Contract #: 04-0120F4Cty: SF/ALA Rte: 80 PM: 13.2/13.9File #: 1x.28**WELDING INSPECTION REPORT****Resident Engineer:** Casey, William**Address:** 333 Burma Road**City:** Oakland, CA 94607**Report No:** WIR-026565**Date Inspected:** 25-Oct-2011**Project Name:** SAS Superstructure**OSM Arrival Time:** 700**Prime Contractor:** American Bridge/Fluor Enterprises, a JV**OSM Departure Time:** 1530**Contractor:** American Bridge/Fluor Enterprises, a JV**Location:** Job Site**CWI Name:** Salvador Merino**CWI Present:** Yes No**Inspected CWI report:** Yes No N/A**Rod Oven in Use:** Yes No N/A**Electrode to specification:** Yes No N/A**Weld Procedures Followed:** Yes No N/A**Qualified Welders:** Yes No N/A**Verified Joint Fit-up:** Yes No N/A**Approved Drawings:** Yes No N/A**Approved WPS:** Yes No N/A**Delayed / Cancelled:** Yes No N/A**Bridge No:** 34-0006**Component:** SAS OBG**Summary of Items Observed:**

## WELDING INSPECTION REPORT

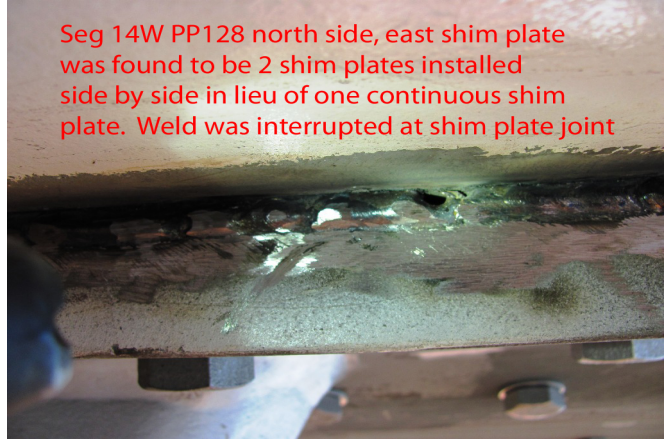
Seg 14W PP128 south side, east shim plate was welded for 400mm of the 760mm total length and wrapped around one end for 35mm due to shim thickness.

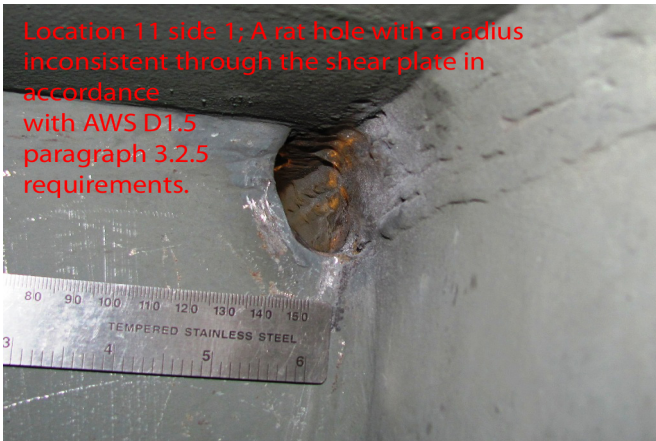
Seg 14W PP128 north side, east shim plate was found to be 2 shim plates installed side by side in lieu of one continuous shim plate. Weld was interrupted at shim plate joint

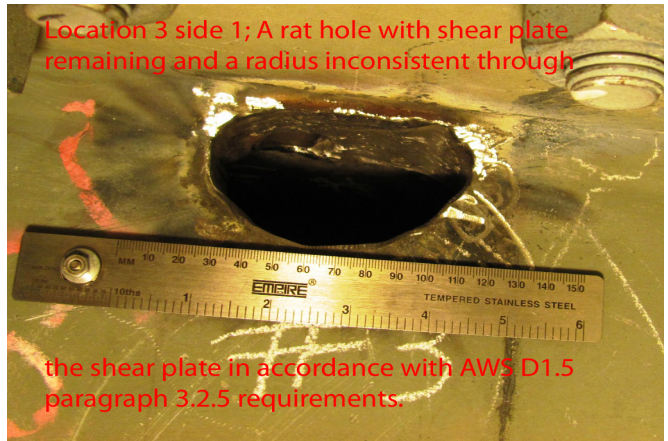
Location 11 side 1; A rat hole with a radius inconsistent through the shear plate in accordance with AWS D1.5 paragraph 3.2.5 requirements.

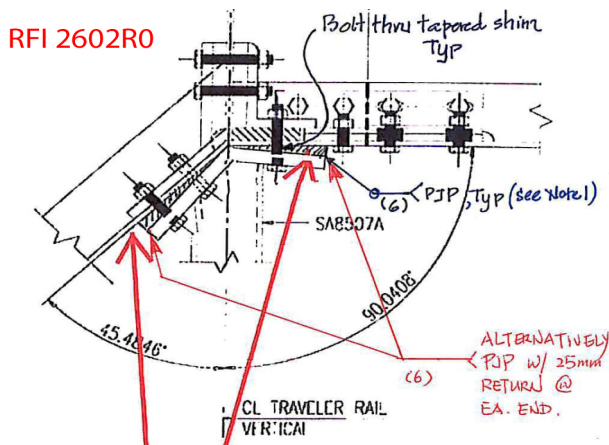
Location 3 side 1; A rat hole with shear plate remaining and a radius inconsistent through

the shear plate in accordance with AWS D1.5 paragraph 3.2.5 requirements.

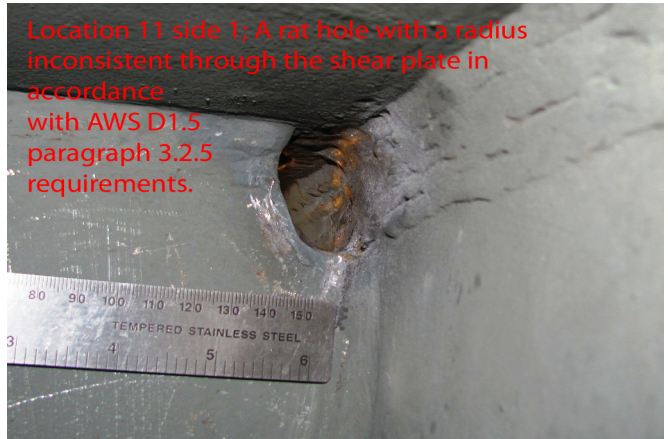
Location 11 side 1; A rat hole with a radius inconsistent through the shear plate in accordance with AWS D1.5 paragraph 3.2.5 requirements.
